## ENGINEERING EVALUATION/FACT SHEET

Application No.:	R13-3224
Plant ID No.:	103-00097
Applicant:	Equitrans Limited Partnership
Facility Name:	Corona Compressor Station
Location:	Brink
NAICS Code:	486210
Application Type:	Construction
Received Date:	November 12, 2014
Engineer Assigned:	Edward S. Andrews, P.E.
Fee Amount:	\$2,000.00
Fee Deposit Date:	November 14, 2014
Complete Date:	December 11, 2014
Due Date:	March 11, 2015
Applicant Ad Date:	November 19, 2014
Newspaper:	<i>Wetzel Chronicle</i>
UTM's:	Easting: 542.78 km      Northing: 4,377.20 km      Zone: 17
Description:	The application is for the construction of compressor station for a natural gas pipeline segment which includes one combustion turbine, two heaters, and five micro turbine generators.

Engineering Evaluation of R13-3224  
 Equitrans Limited Partnership  
 Corona Compressor Station  
 Non-confidential

Figure 1 – Schematic of the Corona Station

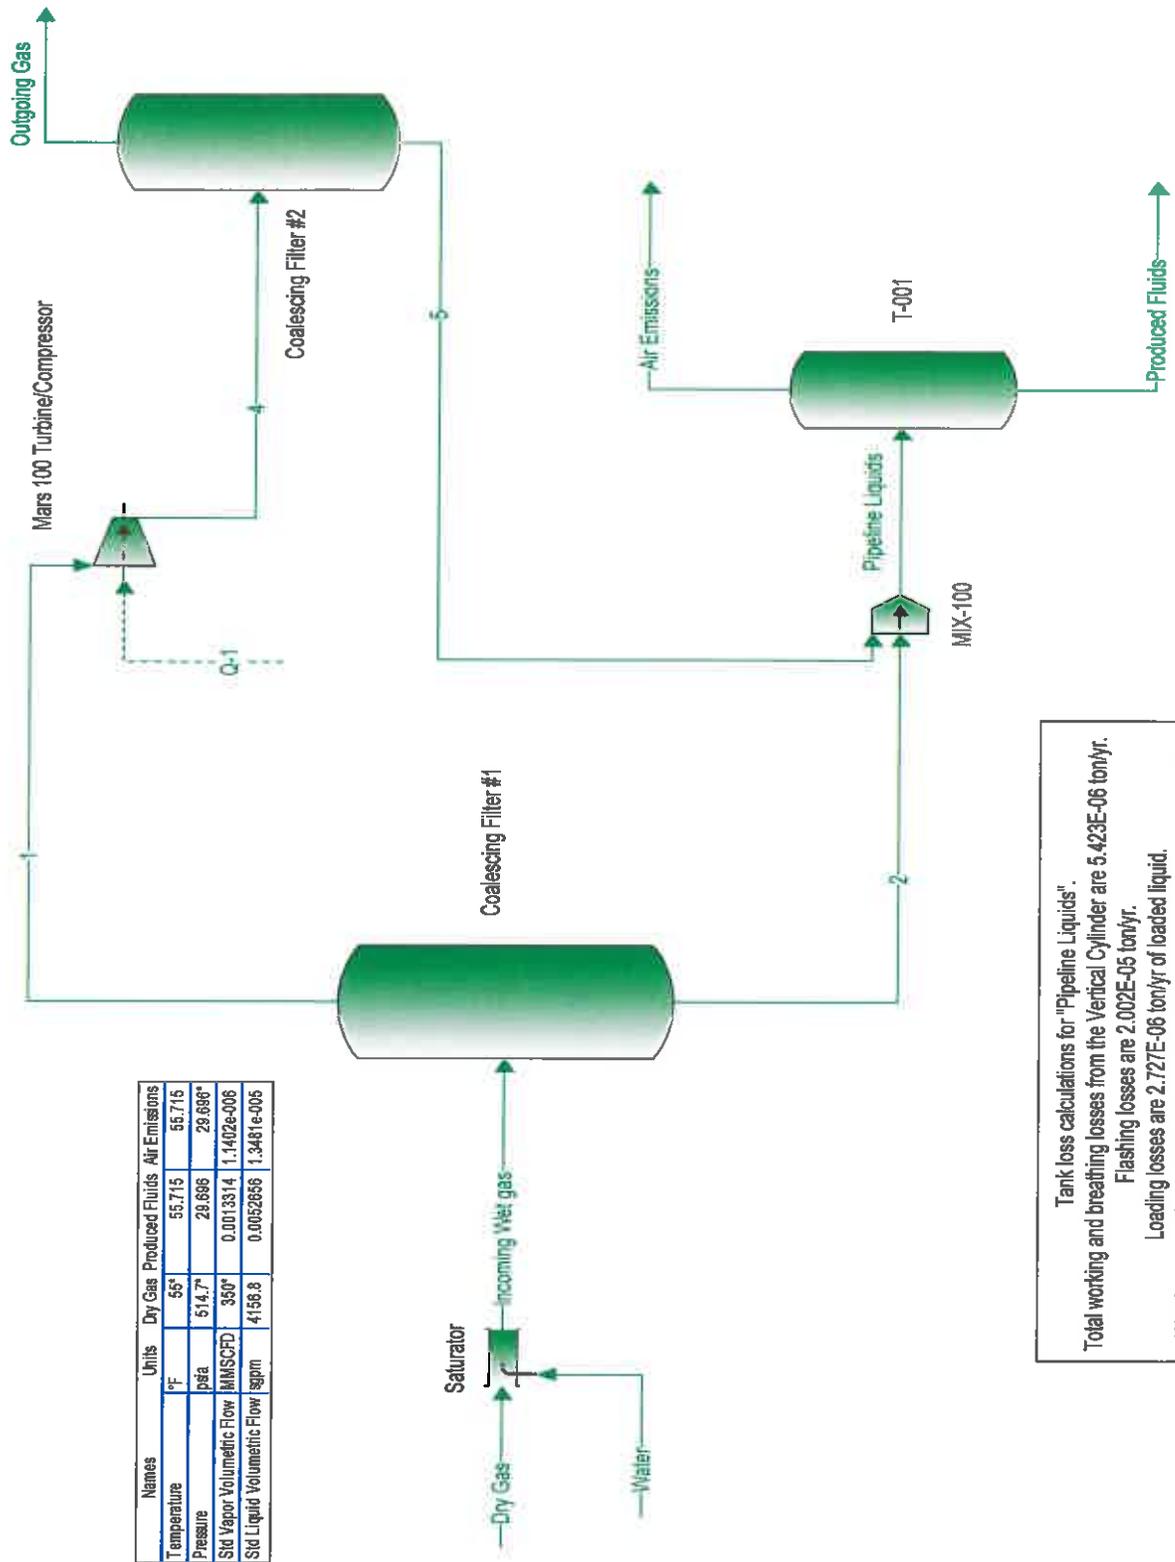
In reviewing the applicant's flashing loss from the produced fluids tank, the writer noted that the ChemCad was predicting that 100% of produced fluids were being flashed off. In addition, the inputs did not include any water. The writer re-evaluated the potential from this vessel at the proposed station using ProMax 3.2.

The writer used the saturator function to account for moisture in the incoming natural gas. The coalescing filters are represented as 2-phase separators operating with a 10 psig pressure drop. Tank T-001 is another 2-phase separator with the tank vent going to atmospheric pressure. The tank losses were calculated using the tank loss property stencil in ProMax 3.2, which uses the working and breathing loss equations from Chapter 7.1 of AP-42 and loading loss equations from Chapter 5.2 of AP-42.

This process simulator predicted the VOC emissions from Tank T-001 to be less than 1 pound per year. The writer believes this estimate is less than what actual VOC emissions from Tank T-001. Both prediction methods are predicting the VOC emissions from Tank T-001 to be very low. Actual pipeline operational data would be needed to enhance the writer's estimation approach.
